### T.Y. LIN INTERNATIONAL

NO.	DATE	REVISIONS	BY
<div style="display: flex; justify-content: space-between;"> <div style="text-align: center;"> <p><b>CASCO BAY STEEL STRUCTURES</b> ONE WALLACE AVENUE SOUTH PORTLAND, ME 04106 PHONE: 207-780-8722 FAX: 207-780-8726</p> </div> <div> <p>STRUCTURE <u>BENMONT AVE. (TH-7) (URBAN MINOR ARTERIAL)</u></p> <p>LOCATION <u>TOWN OF BENNINGTON, VERMONT</u></p> <p>PROJECT NO. <u>BRIDGE NO. 57 PROJECT NO. BRF 1000(16)</u></p> <p>ENGINEER <u>STATE OF VERMONT AGENCY OF TRANSPORTATION</u></p> <p>CUSTOMER <u>ALPINE CONSTRUCTION</u></p> <p>ITEM <u>GIRDER ~ 2G2A</u></p> <p>SURFACE PREP. <u>SSPC-SP10</u> OPEN HOLES <u>1 1/8\" (UN)</u></p> <p>PAINT <u>NONE</u></p> </div> </div>			
APPROVAL	DRAWN	GDC	12-8-14
SHOP	CHECKED	PH	1-3-15
SHEET NO. <b>2B</b>		JOB NO. <b>605</b>

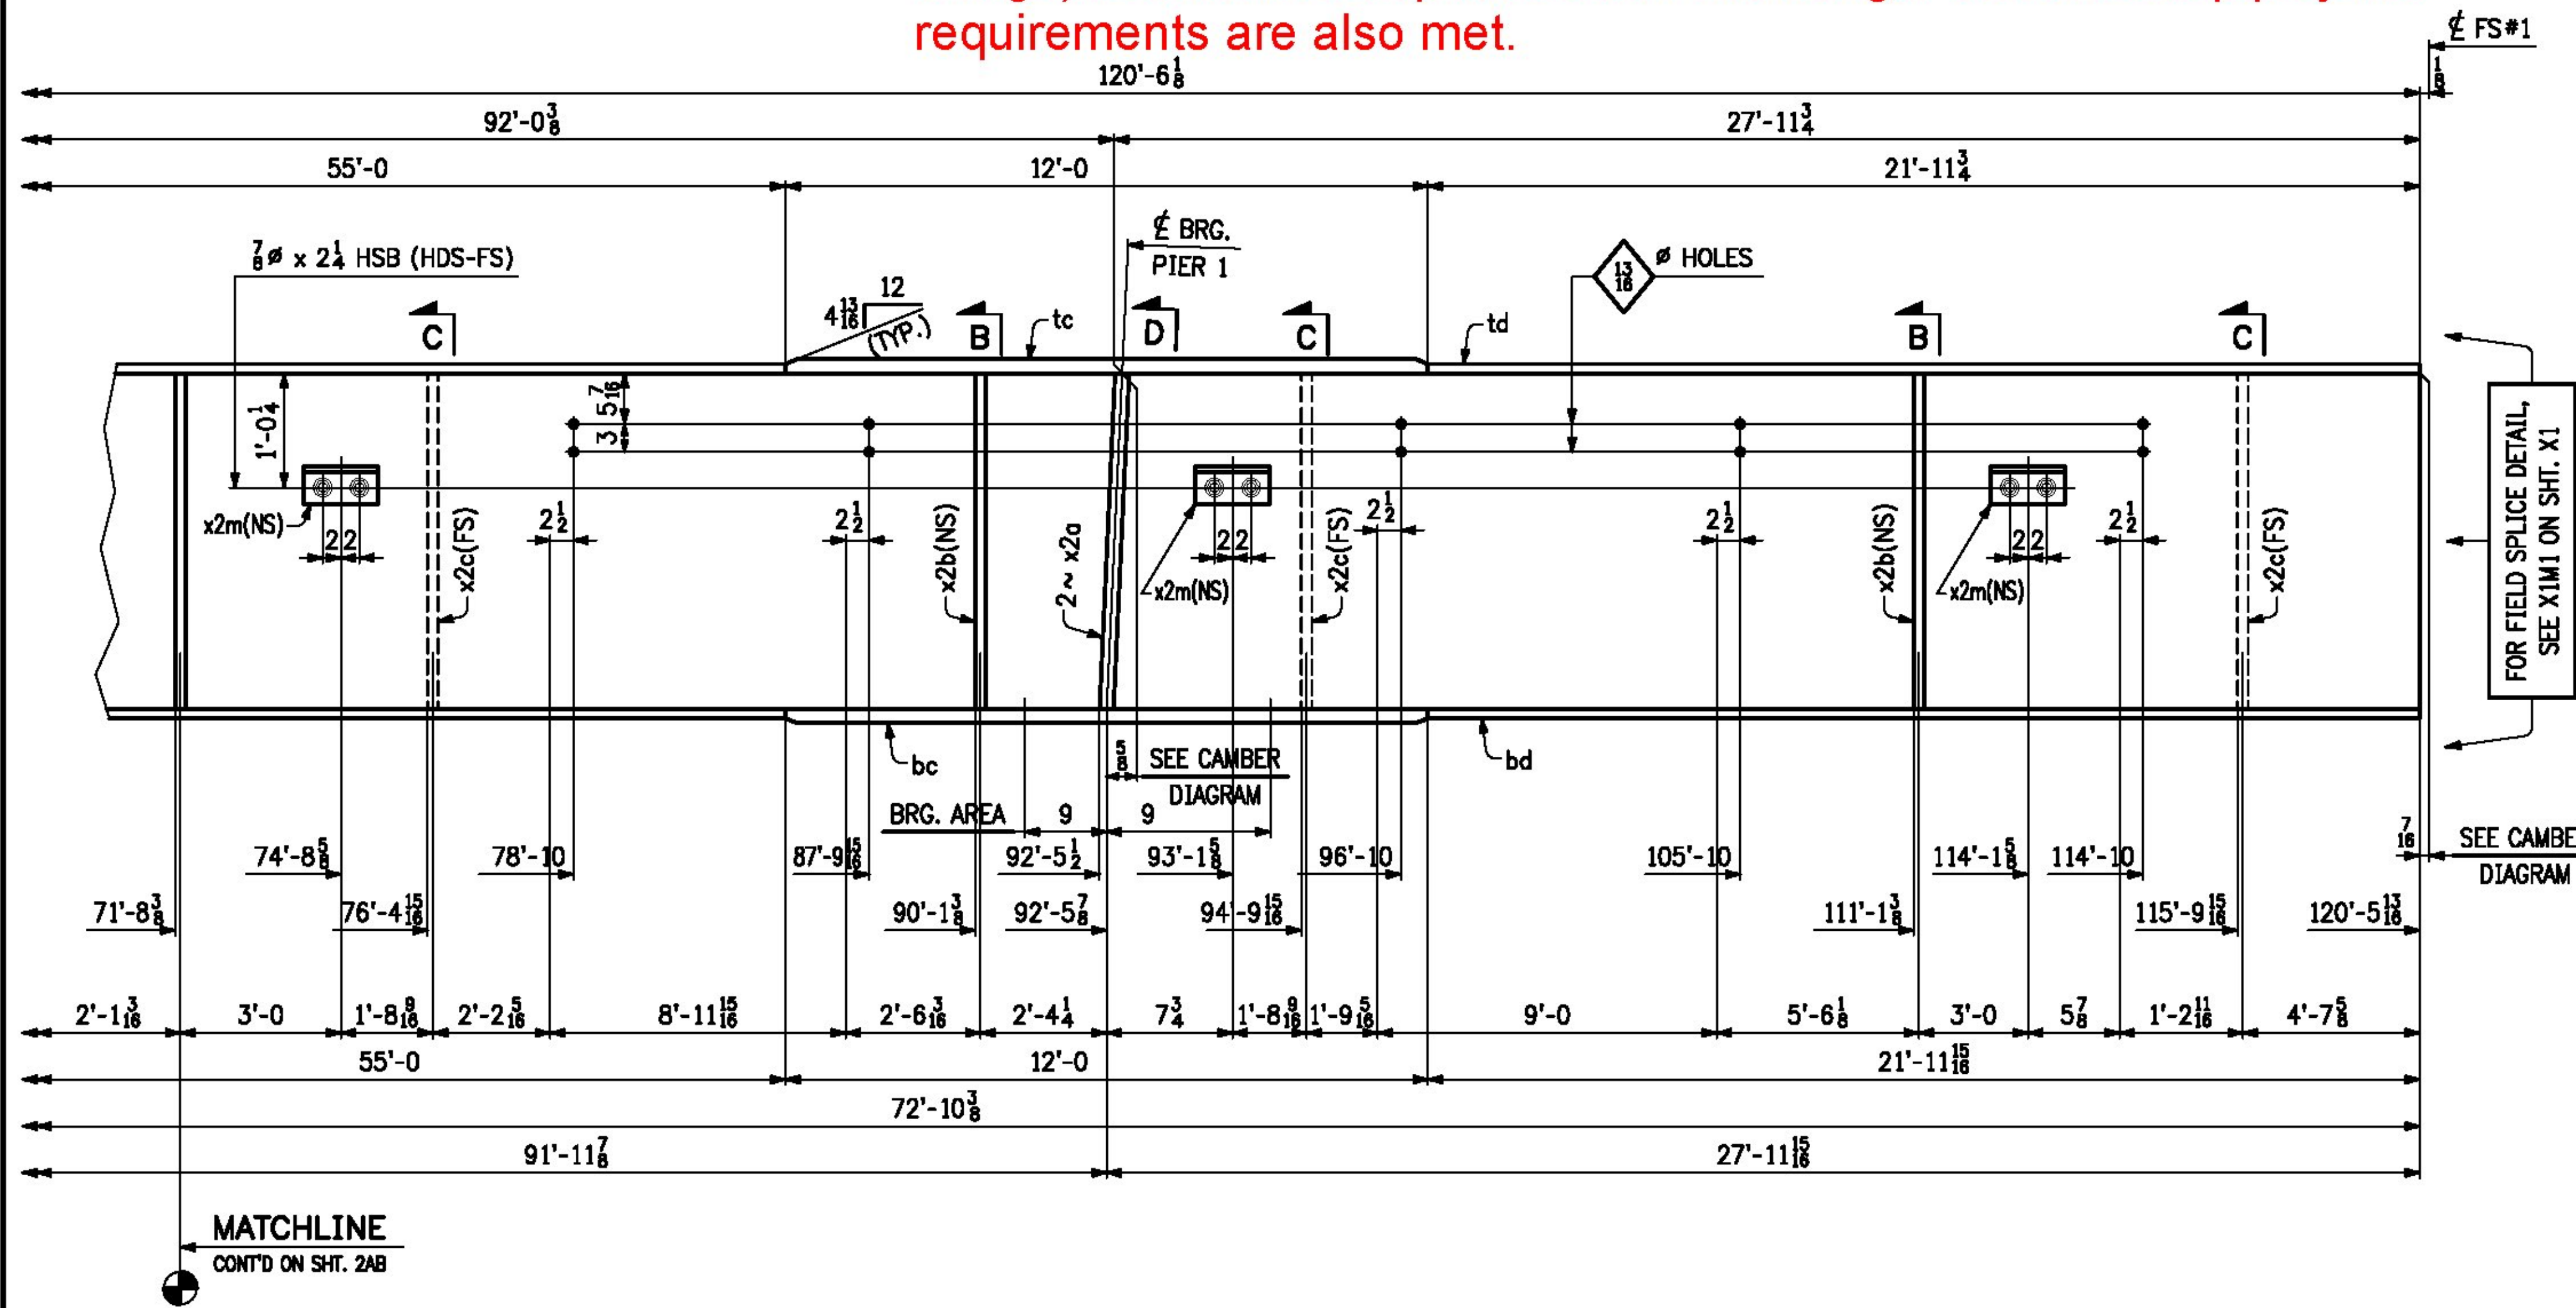
Spacing of waterline support beams are not all at 9'-0" spaces as shown on Contract Drawing Sheet 39 of 75. Maximum variation appears to be 9". The increase in span is acceptable, however the Contractor should refer to the Special Provision (Water Main on Bridge) to ensure compliance with the hanger distance to pipe joint requirements are also met.
